PARTS LIST FOR MODEL SSV5500

MRP Ver 100314
(based on Penn's Rev. 4 10-01-14)

Penn Reel Parts list for Model: SSV5500 Spinfisher V

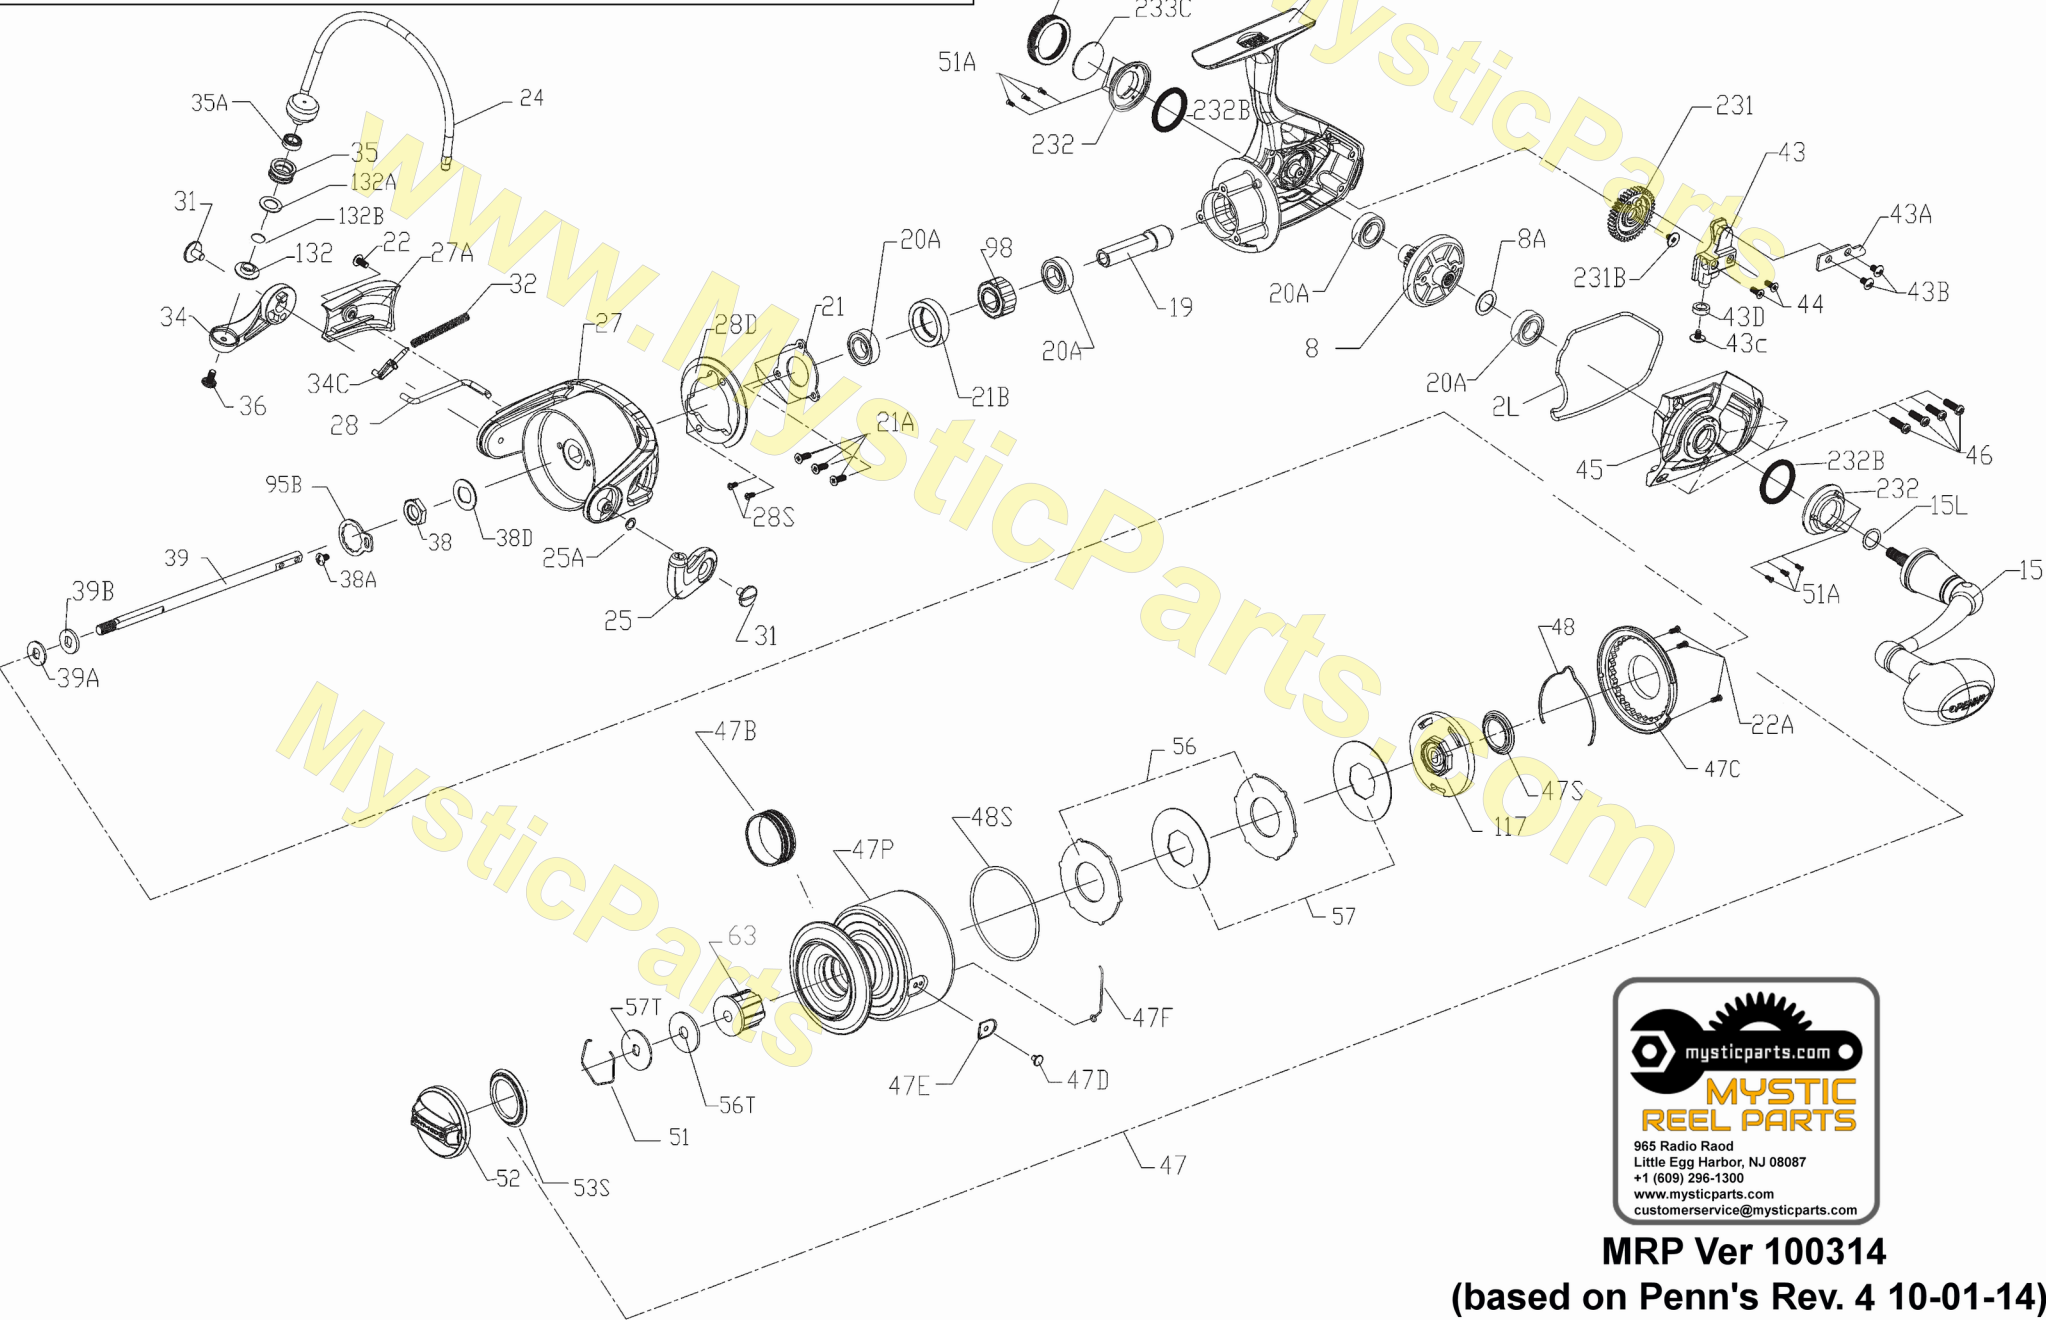
Design Change!
See notes on page 3
about these part numbers

These parts below were removed by Rev 3, we are not yet sure why.

REV 3. Bearing number changes

We are assuming there were errors with the bearing part numbers on the schematic, rather than that they actually changed the bearings.

*****Design change after first run

Early SSV5500 run had a slightly different housing and crosswind gear
The diameter of the hole in the crosswind was almost 3/8". Later runs, the crosswind gear and the pin in the housing that it sits on must have been changed.
The current gear I.D. is .23" just under 1/4", current housing matches it.

RECOMMEND TO USE THE REVISION 4 NUMBERS

1	1277034	1-SSV5500	HOUSING, BODY ASSEMBLY
231	1277098	231-SSV5500	CROSSWIND OSCILLATION GEAR 0.23" I.D.
45	1277073	45-SSV5500	HOUSING / BODY COVER
1	n/a	1-SSV5500	HOUSING, BODY ASSEMBLY with .309 peg
231	n/a	231-SSV5500	CROSSWIND OSCILLATION GEAR 1st run 0.309" I.D.
45	n/a	45-SSV5500	HOUSING / BODY COVER
